STAFF REPORT

APPLICATION NO:	PLAT-2024-03		
HEARING DATE:	October 10, 2024	NEXT HEARING DATE:	November 14, 2024
NEWSPAPER NOTICE PUBLISHED ON:	Unknown	NOTICES MAILED ON:	Unknown
SUBJECT:	Primary Plat review		
LOCATION:	Lapel Industrial Park; East side of SR 13, 950 feet south of SR 38		
PETITIONER(S):	Dorsey Roscoe, CRPP, LLC		
ENGINEER/SURVEYOR:	Mike Deboy, Brent White, Deboy Land Development Services		
SUMMARY:	Commission to consider a Primary Plat for Lapel Industrial Park subdivision containing about 39 acres and proposing 4 lots and two blocks.		
WAIVERS REQUESTED:	None		
RECOMMENDATION:	CONTINUE TO THE NEXT MEETING		
PREPARED BY:	Oksana Polhuy, Planning Administrator		
EXHIBITS:	Exhibit 1. Primary Plat Exhibit 2. Planning and Engineering review letter Exhibit 3. Feasibility Report from the petitioner Exhibit 4. Drainage Approval Exhibit 5. Letters from the Utilities

PLANNING TAC COMMENTS

Comments from: Oksana Polhuy
Application #: PLAT-2024-03
Applicant: Dorsey Roscoe, CRPP, LLC
Surveyor/Engineer: Mike Deboy, Brent White, Deboy Land Development Services
Location: East side of SR 13, 950 feet south of SR 38
Project name: Lapel Industrial Park, Primary Plat
Date: October 3,

C500

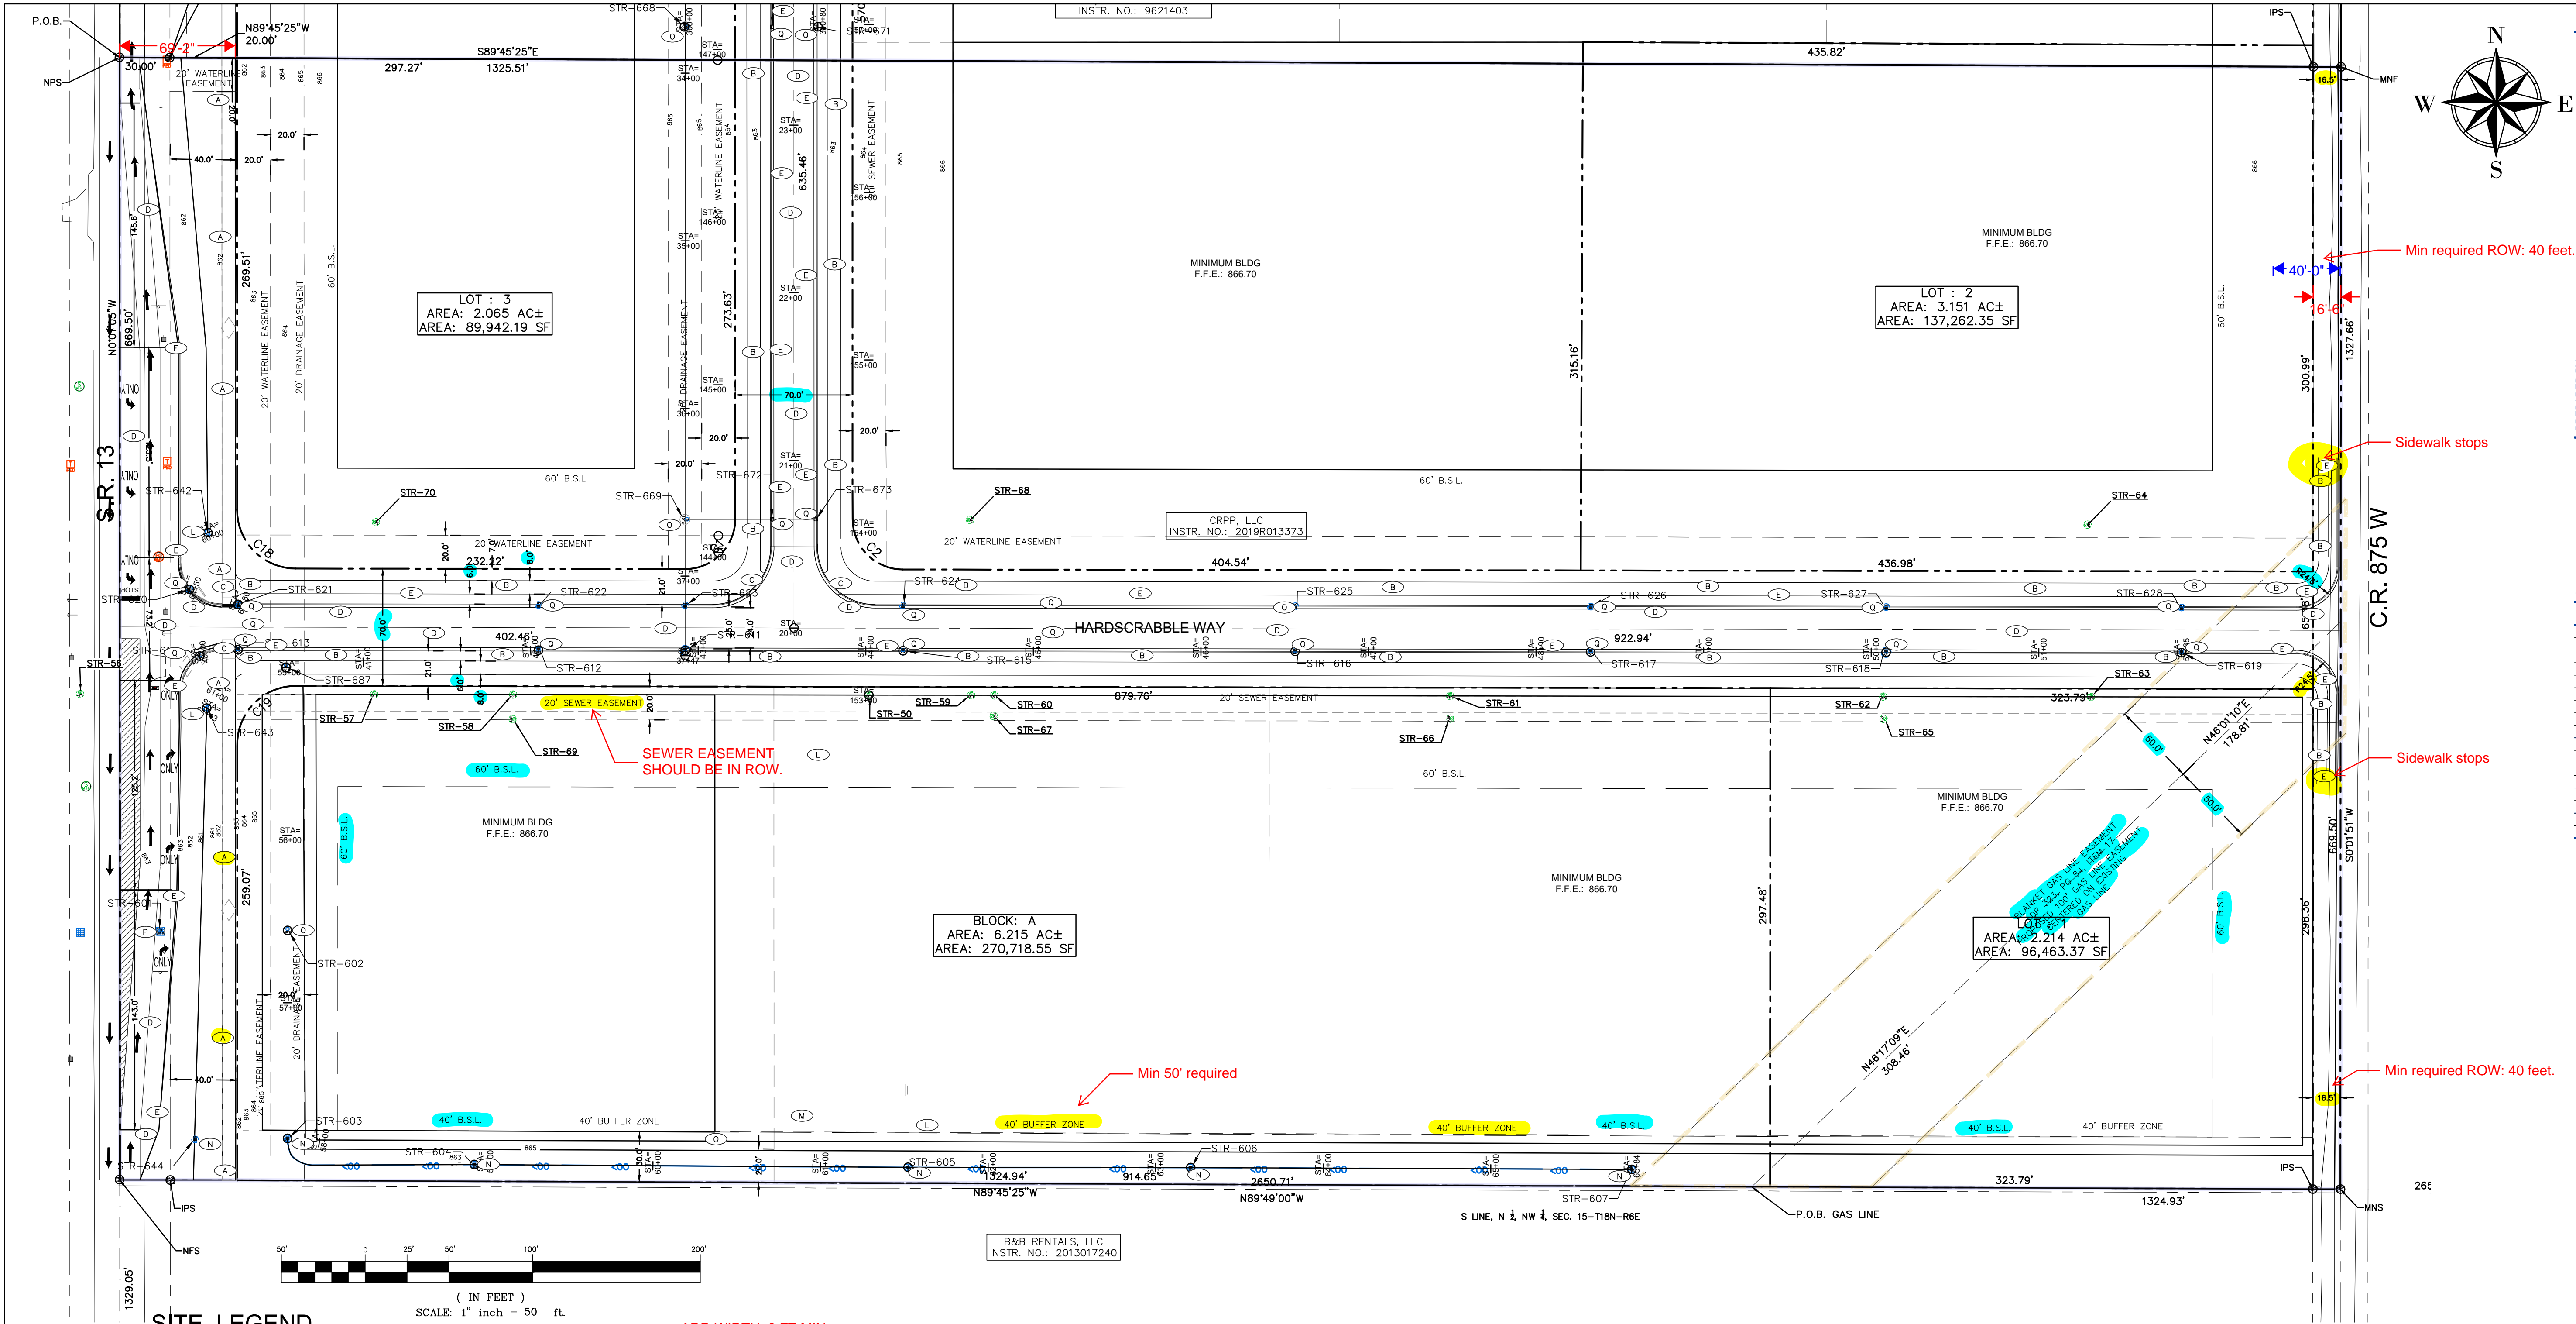
☐ **Sidewalk width.** The sidewalk width along SR 13 and CR 875 W shall be at least 8 feet. Please, add the width of this sidewalk to the plans.

ADD WIDTH: 8 FT MIN.
MIN 2' REQUIRED
